Brooks Acoustics Corporation

27 July 2022
PJ2022-1388-02

Subject: Acoustical engineering study – Sound analysis for Conditional Use Permit
Oro & Elixir – 818 Lincoln Road, Miami Beach
Response to Peer Review – PB 22-0518 – Prepared by Arpeggio, July 21, 2022

Sound Source Contribution Plot
Pos 1 - Sidewalk to North
Based on BAC sound data and proposed site plan
Sidewalk to North (baseline elev. 5) - Impact windows
Dance Floor on venue 3rd floor

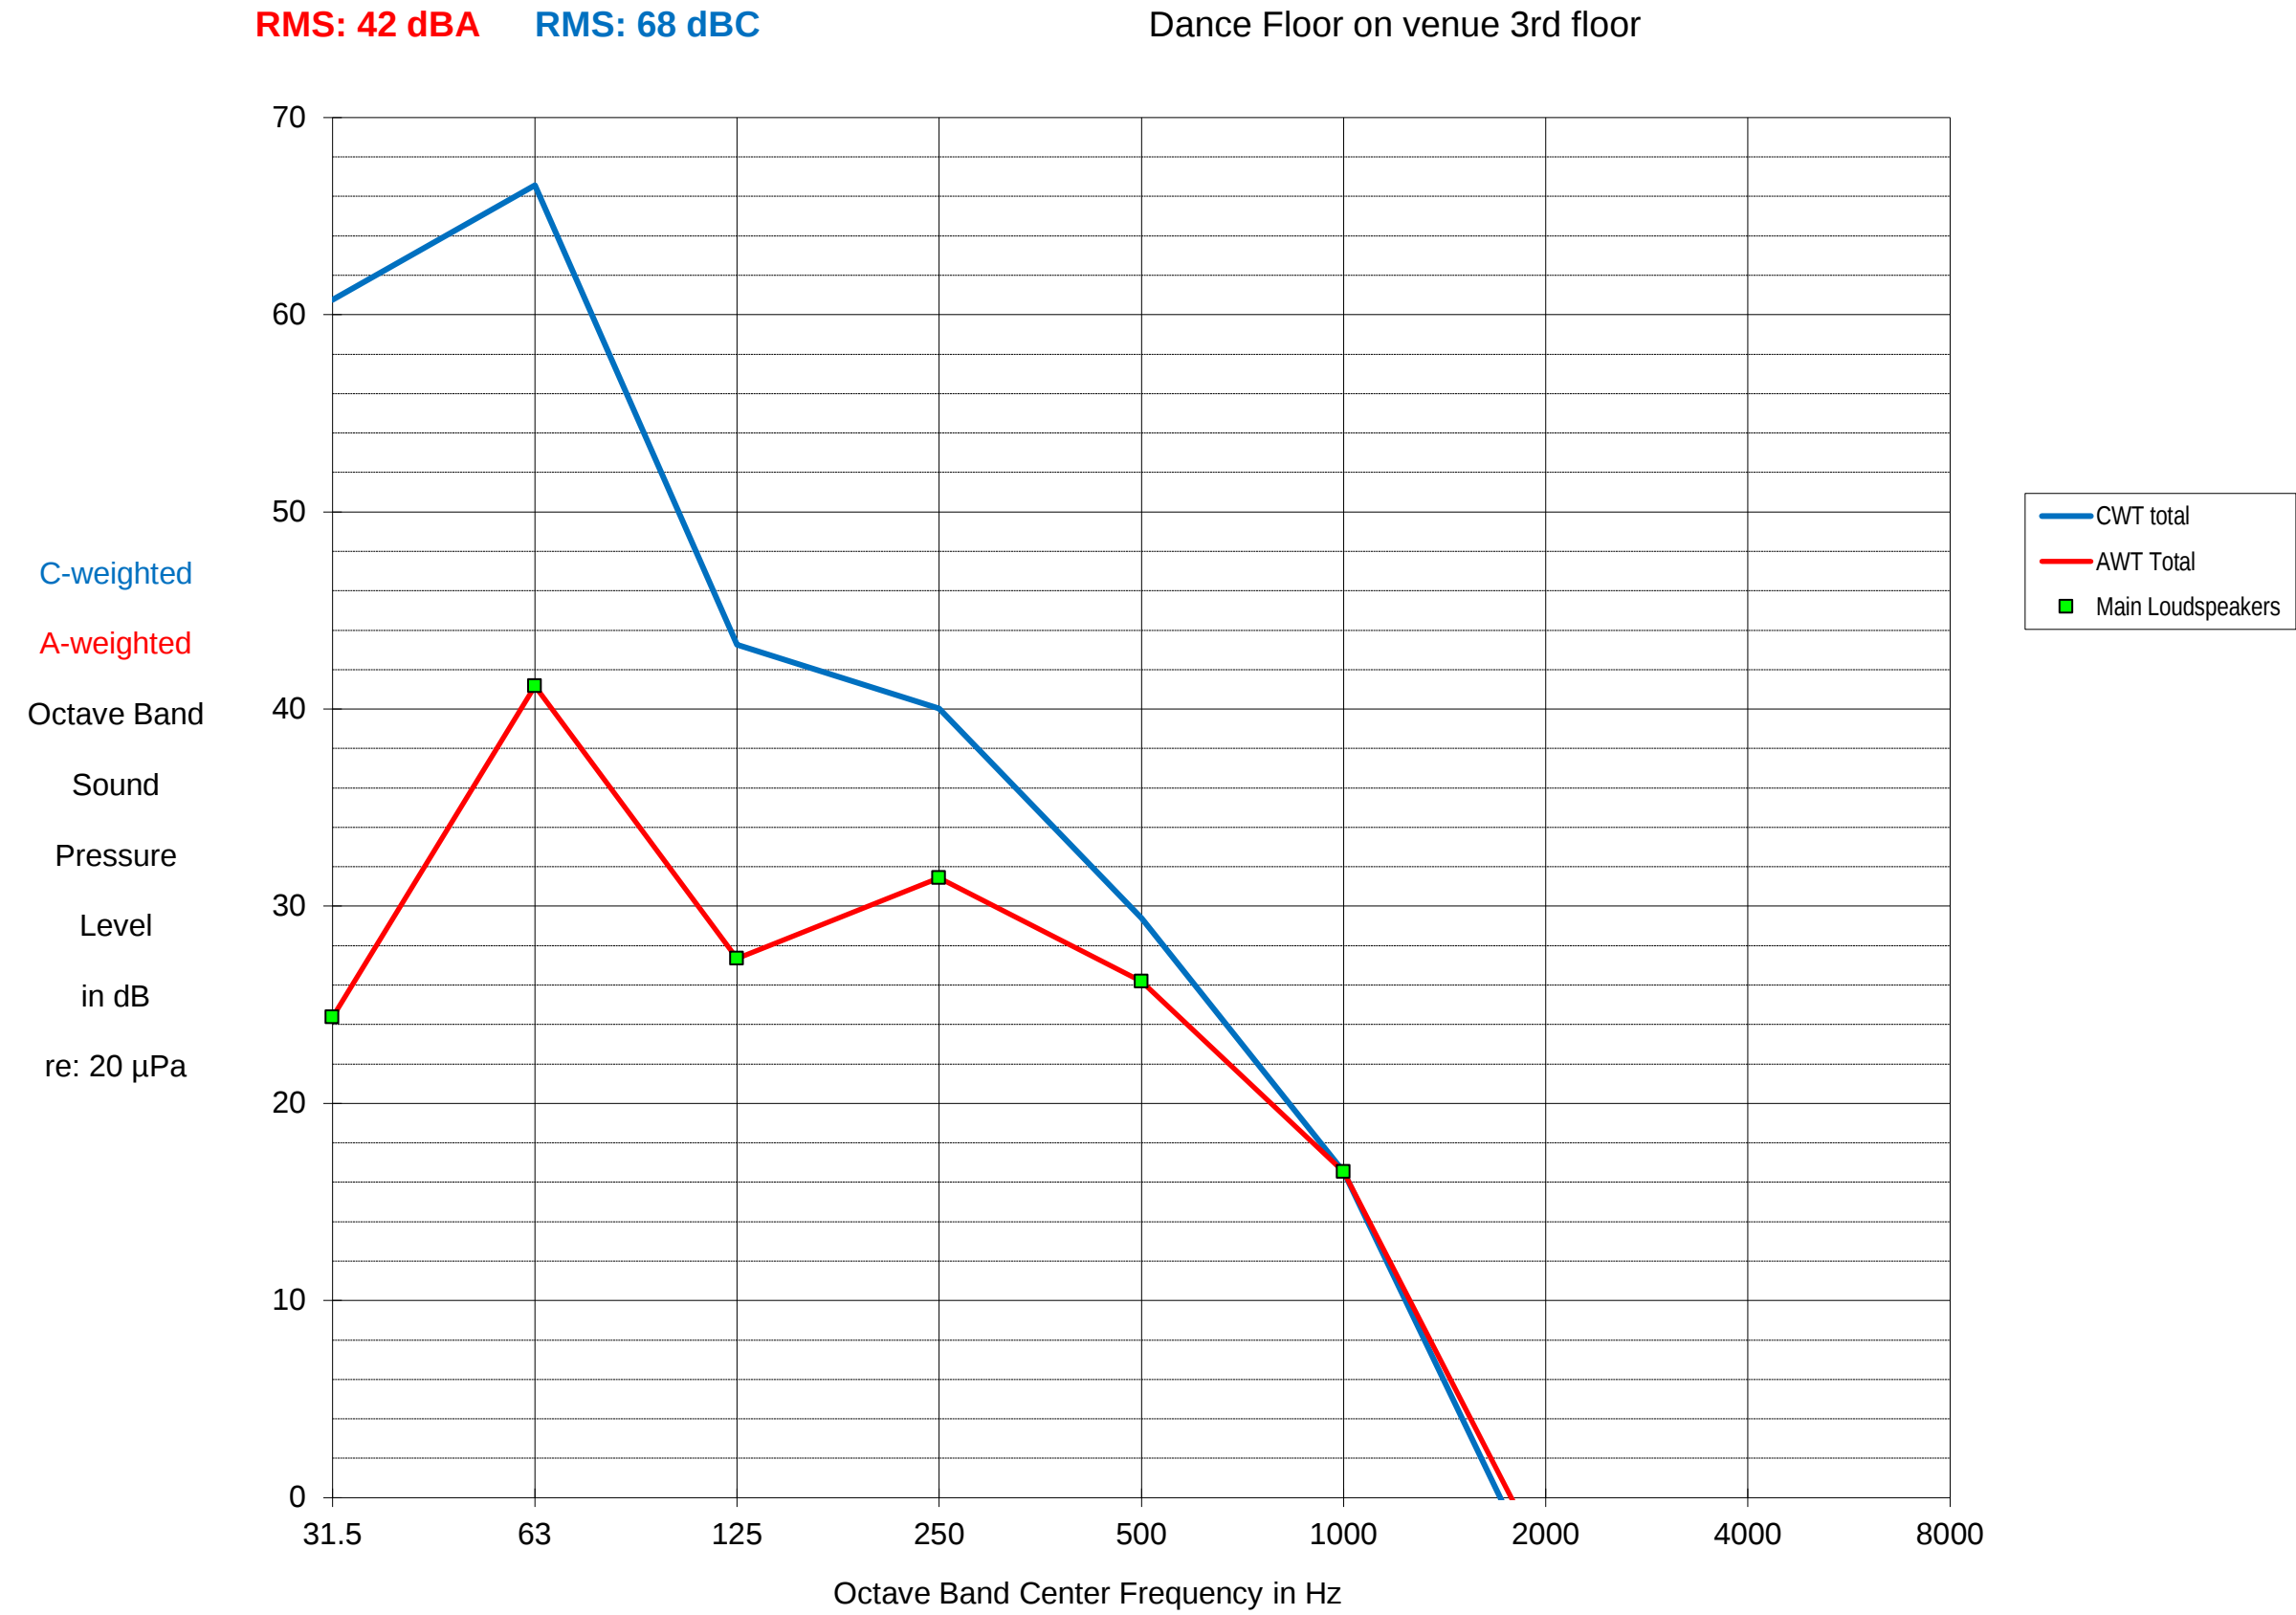
The Peer Reviewer suggested that BAC revise its sound analysis to include:

1. Window sound attenuation - as the Operations Plan indicates that the outdoor terrace on the third floor would be closed when there are live musical performances within that exceed ambient levels.
2. Calculation of C-weighted sound levels (decibels) at the receivers.

1. Include window sound attenuation
2. Calculate C-weighted sound levels (decibels) at the receivers.

The sound level calculated at Position 1, the Mall sidewalk to the north, with the venue third floor windows closed is about **42 dBA** (42 A-weighted decibels), the level of a *whisper*. The C-weighted level is **68 dBC**. This is expected to be consistent with or below the ambient sound level in the area.

Criteria Level **70 dBA**
80 dBC
Total Sound Level **42 dBA**
68 dBA
Compliance? **YES**
